From: Havis, Sean <[REDACTED]>
Sent: 21 January 2022 16:39
To: Simon Davis
Cc: Sparkes, Jessica
Subject: RE: *EXTERNAL: Y/167/21/DOC Cond 12
Attachments: 20220106_074537.jpg; 20220106_074547.jpg; 20220106_074638.jpg; 20220106_074503.jpg

From: Simon Davis <Simon.Davis@arun.gov.uk>
Sent: 14 December 2021 19:01
To: Havis, Sean <sean.havis@barrattdw.co.uk>
Cc: Sparkes, Jessica <jessica.sparkes@arun.gov.uk>
Subject: *EXTERNAL: Y/167/21/DOC Cond 12

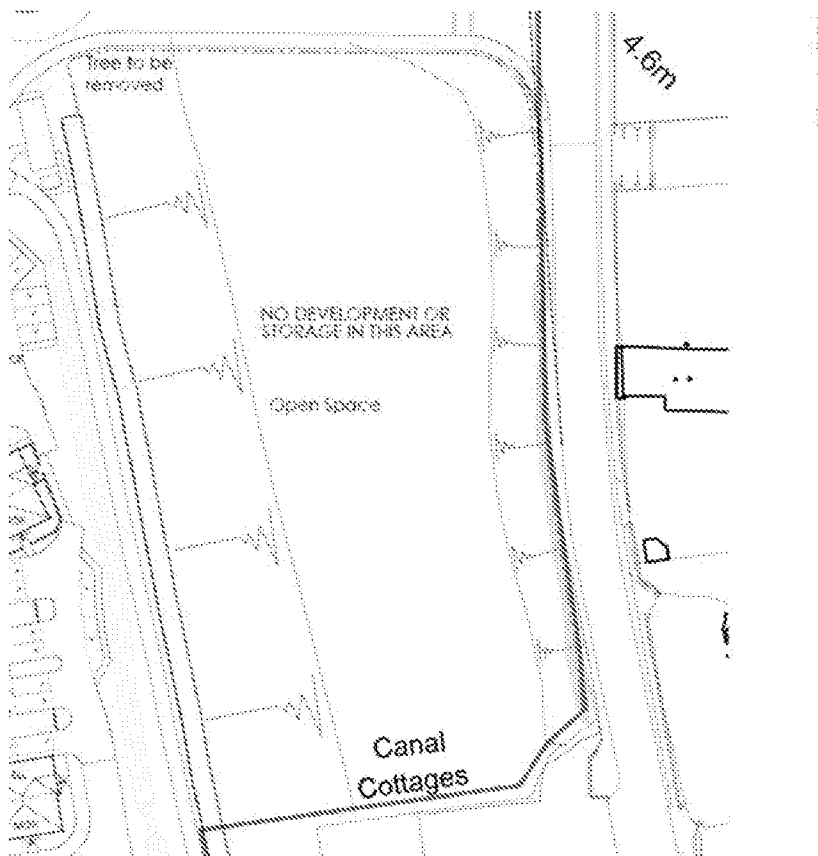
I have reviewed the plans/statements included as part of the application and am of the opinion that insufficient information has been provided. At present there is only a very basic reference to the 'Metal Estate Railing' on the boundaries plan. It is not clear how much of the existing railings will be re-used or how much of it will need to be replaced (or the reasons why). Further, there is no information regarding the proposed replacement railings, especially regarding their design, appearance, and treatment. It is also not clear if the existing railings will be painted or repaired in any way. This is disappointing, and the information should be provided in order for the LPA to fully understand the proposals.

We need to see full details of what is being proposed and there is a strong preference for retention of as much of the existing fencing as possible. We will need a detailed plan indicating which sections are being retained and which sections require new fencing (and then we need to know what kind of new fencing will be used – and this should match as far as possible to the existing). Please provide further details by the 5th January 2022.

Please find attached some photos showing the extent of fencing that is retained. Only a small section has been removed where the new footpath was required, however a lot of it is in a bad state as it has been within vegetation for many years and has not been looked after, being twisted and broken by trees, animals, etc.

It is going to be very tricky to repair the fencing to a 'good' standard and I would instead suggest we replace the fence where possible (the extent not highlighted in yellow below) with the same post and 3-rail metal fencing as existing. I can ask our Commercial team to find a fence profile that is similar to the existing if this approach is agreeable?
